## Product Change Notification - SYST-03FYTJ911

ERRATA - KSZ9563R Silicon Errata and Data Sheet Clarification Errata Document Revision

## KSZ9563R Silicon Errata and Data Sheet Clarification

**FIGURE 2: IEEE DOCUMENT PAGE 6**

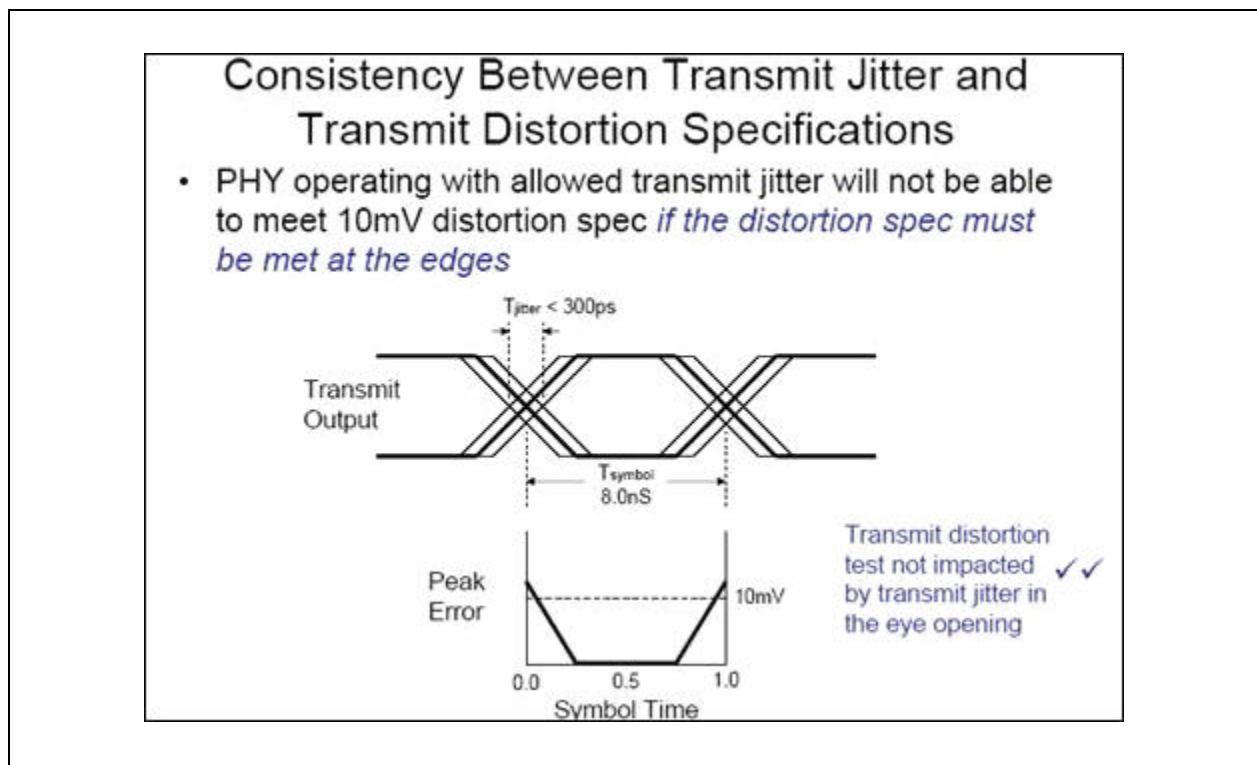
IEEE testing calls for <10mV peak transmitter distortion for at least 60% of the UI within the eye opening. However, this measurement might not be valid, as the transmit distortion test is sensitive to transmit jitter. Refer to the explanation below, taken from the aforementioned IEEE document.

- On page 6, a contradiction between Transmit Jitter and Transmit Distortion requirements:
